ARCHITECTURAL REVIEW BOARD AGENDA

Item: VAR2020-00025; Hacienda Bar and Grill; 252 W. Pike Street

**CITY OF LAWRENCEVILLE
PLANNING DEPARTMENT
VARIANCE REPORT
ARCHITECTURAL REVIEW BOARD**

Item: APPL2020-00002; Kyle Puttkammer; 116 East Crogan Street

SHEET TITLE:
PROPOSED
FRONT & REAR
ELEVATIONS W/ OUT
NEW ROOF

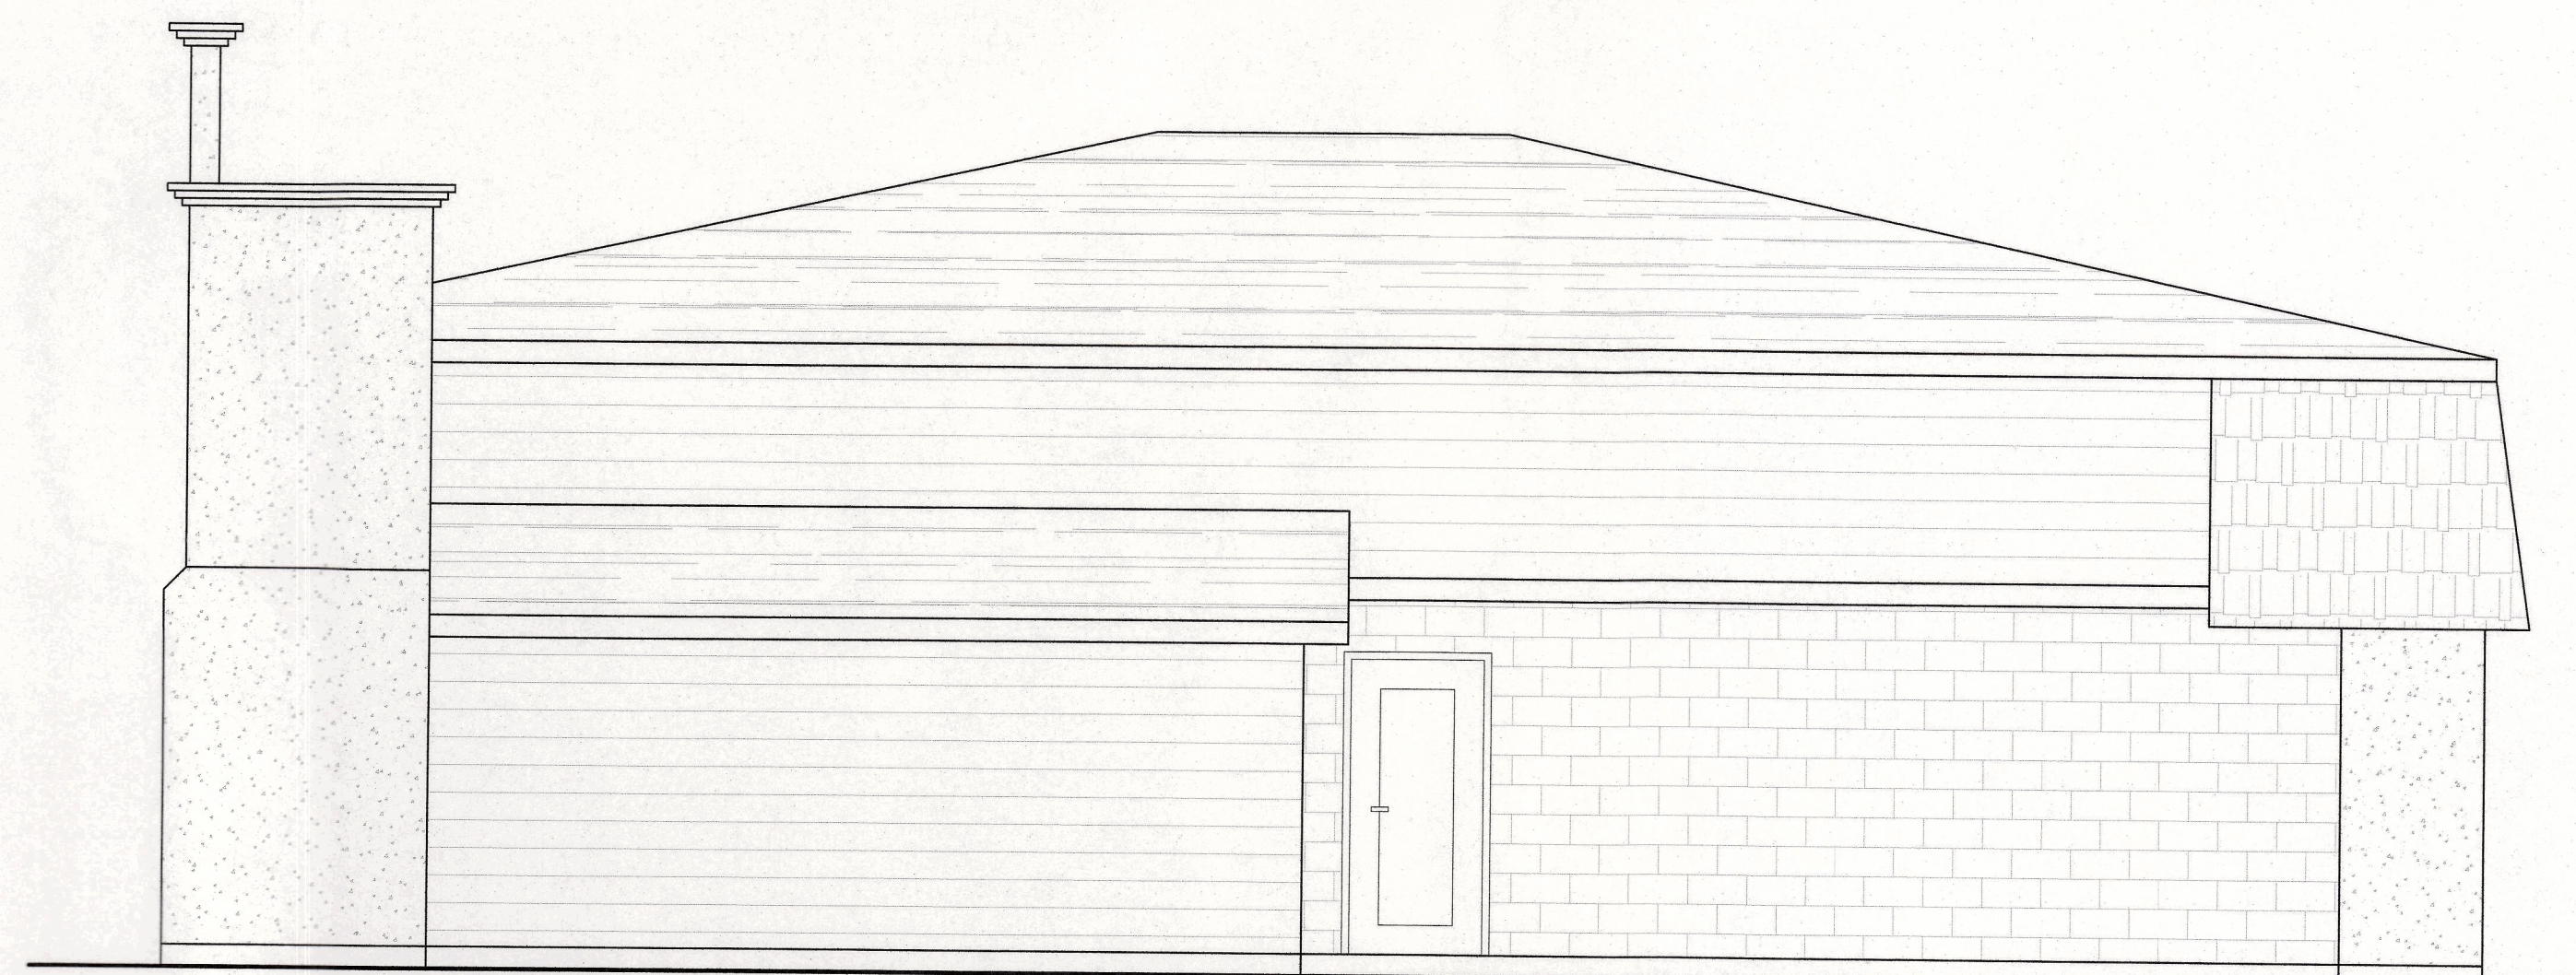
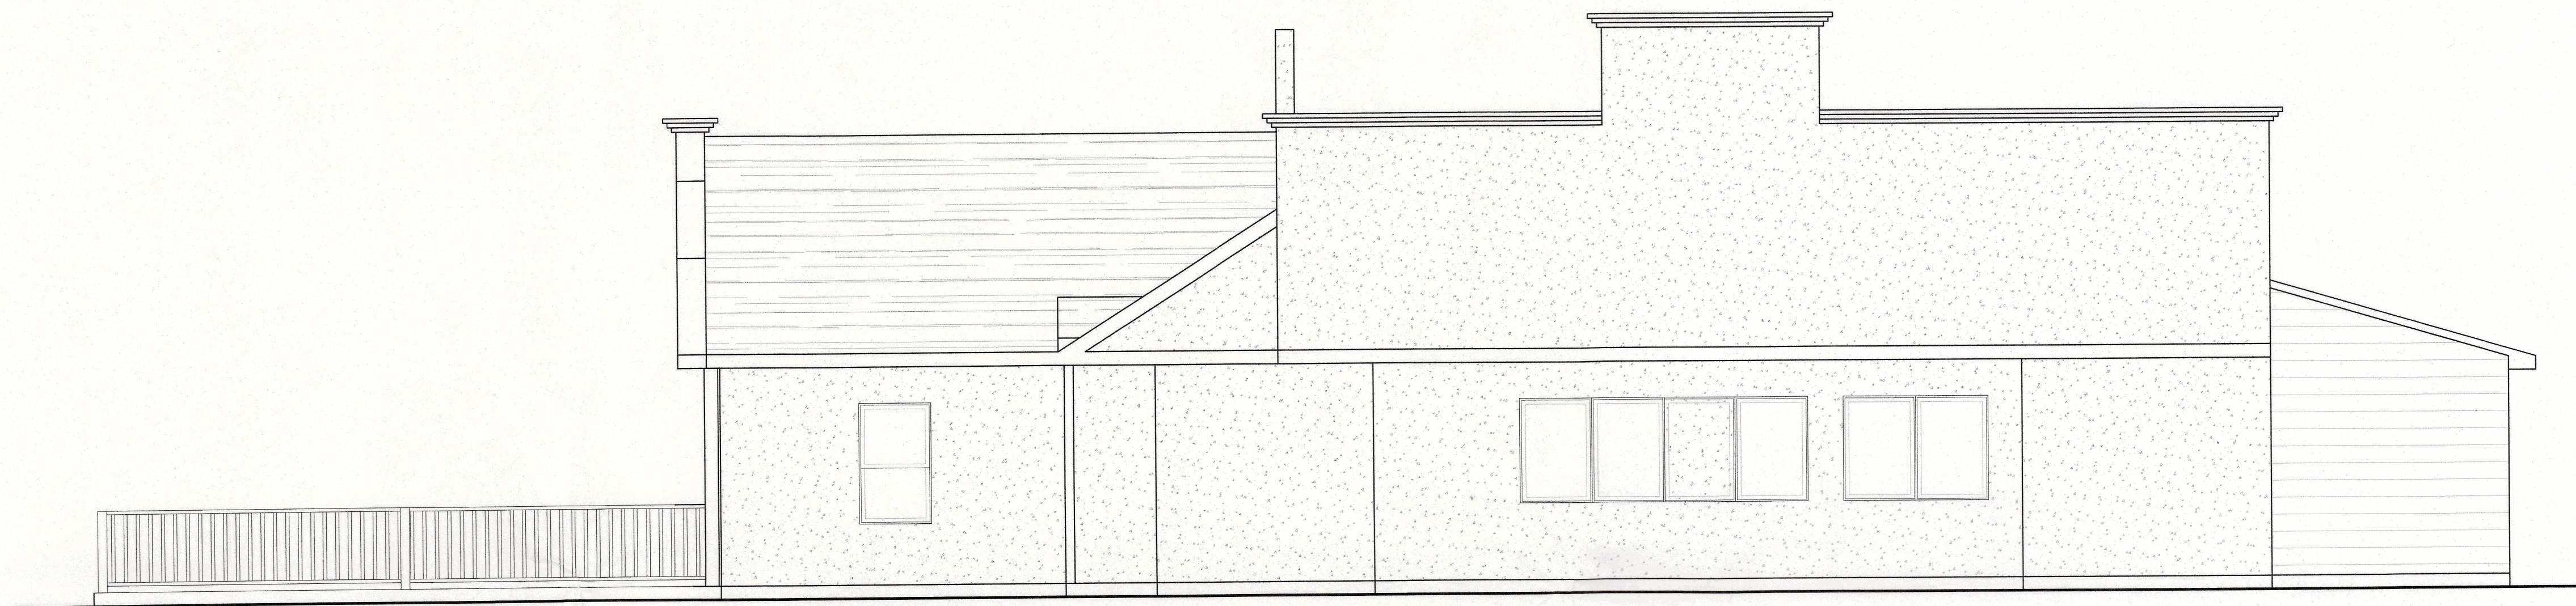
The applicant is proposing to remodel the existing structure located at 252 West Pike Street, and continue to use the associated driveways and parking. The applicant is requesting a variance to allow a change to the front façade of the existing building, which currently consists of exterior architectural treatments of stucco and finished wood. The applicant submitted two sets of plans; plan A (A.9 in attachments) proposes an open patio, plan B (A.7 in attachments) the second proposes a covered patio with a clay tile roof. According to the submitted materials, the existing roof would be modified with metal sheets, per the plan shingles would remain on the left side elevation. The plans show that the rear elevation would continue to have block and wood siding. The applicant is also requesting approval to paint the restaurant with City approved colors; Roycroft Copper Red for window frames and arches and Birdseye Maple for walls.

Article VIII, section 8.7 Minimum Architectural Standards require all BGC zoning districts, metal is not an approved material for facades, however, metal roofs above 3/12 pitch must be standing seam. Section 8.8, Building and Sign

Structure Colors state that muted, subdued, or earth tone colors are encouraged while the use of novelty and primary colors are to be avoided. Colors are intended to enhance the architecture of the project, not to attract attention to specific features or elements such as roof or parapet lines and signs.
